APRIL 1, 2021 OGB SUBMISSION
RESPONSE TO JAN. 7, 2021 MEETING
3220 PROSPECT STREET, NW
WASHINGTON, DC

OLD GEORGETOWN BOARD MEETING DATE: APRIL 1, 2021
CASE #: OG 14-154/HPA 14-324

COMMENTS FROM OGB MEMBERS WHICH HAVE BEEN INCORPORATED INTO THE CURRENT DESIGN

BRICK COLORS - MEDIUM RED & MEDIUM GRAY

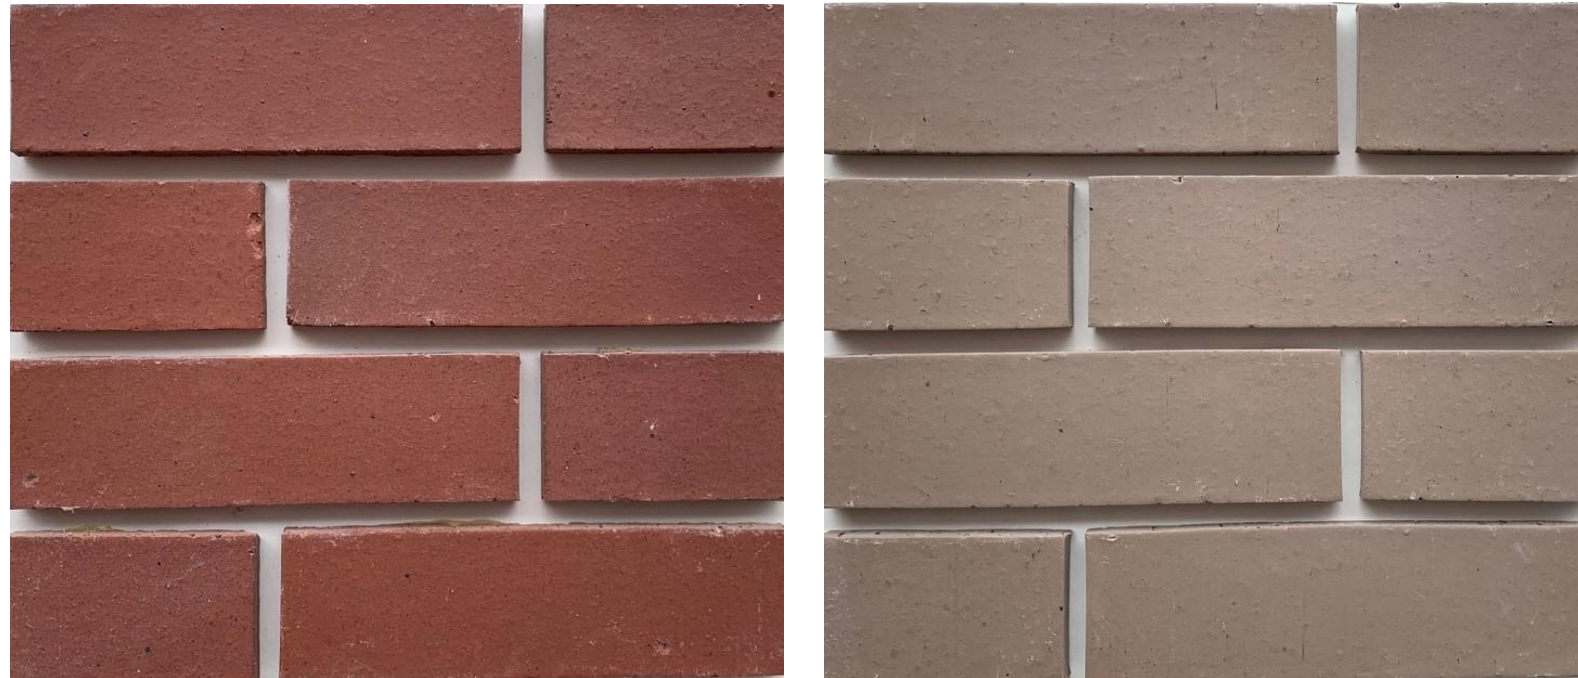
- EXTEND THE BRICK RUSTICATION, WHICH PREVIOUSLY WAS ONLY SHOWN AT THE EAST PORTION OF THE FACADE.
- PROCEED WITH THE RED BRICK FACADE OPTION.
- ON SHEET A-29, WE CHOSE THE RED BRICK OPTION, BUT SELECTED A DARKER GRAY BRICK FOR LESS CONTRAST.

- BAY BRICK TO BE THE SAME COLOR AS THE MAIN BUILDING BRICK BEHIND IT.
- THE SECTION ON SHEET A-25 WAS CORRECTED TO ASSURE ADEQUATE TRUCK TURNING ABILITY.

VIEW FROM M STREET @ ATHLETA
NOVEMBER 5, 2020

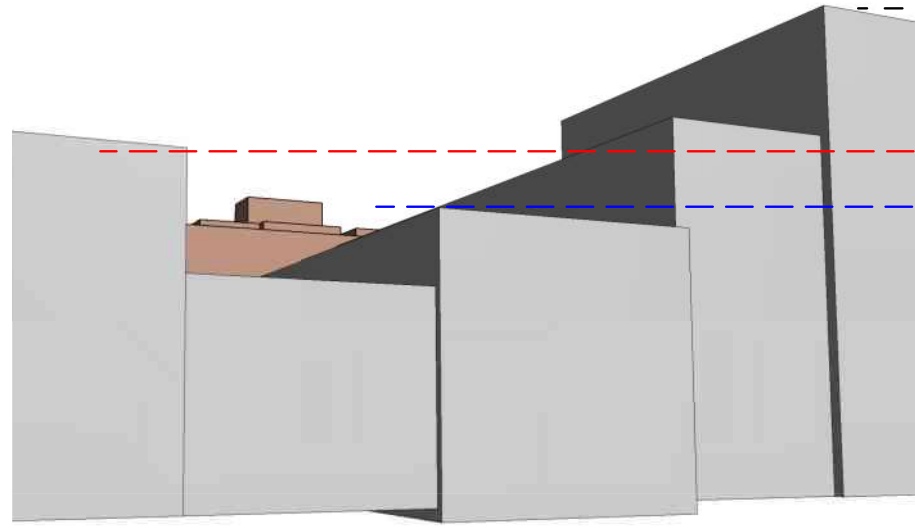
PENTHOUSE ON TOP OF 5TH FLOOR ELIMINATED

VIEW FROM M STREET @ ATHLETA
NOVEMBER 5, 2020

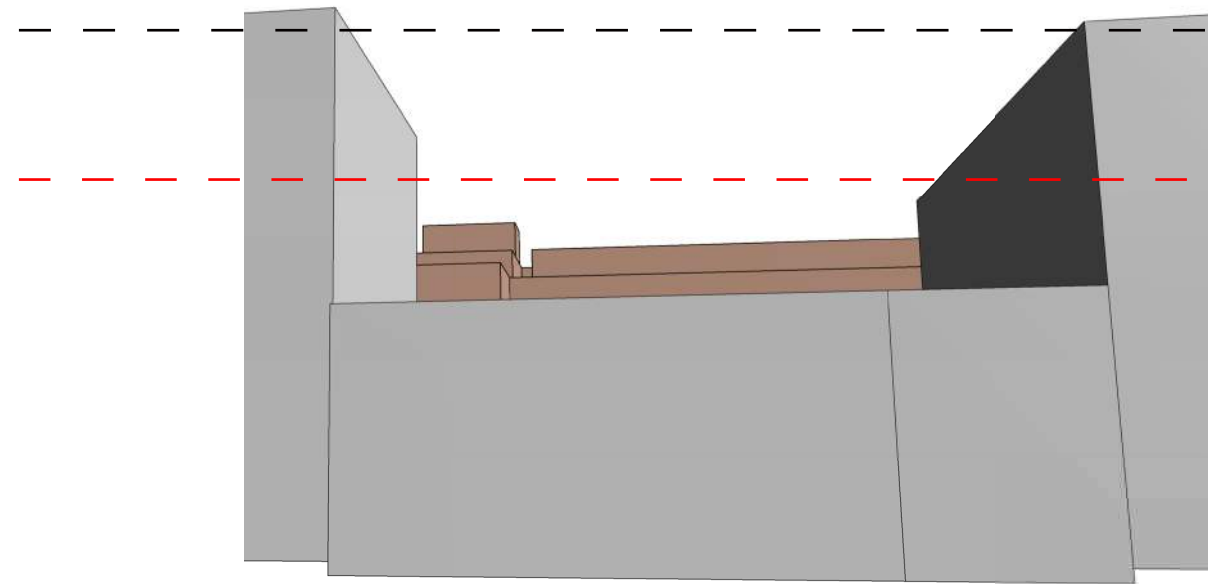
PENTHOUSE ON TOP OF 5TH FLOOR ELIMINATED
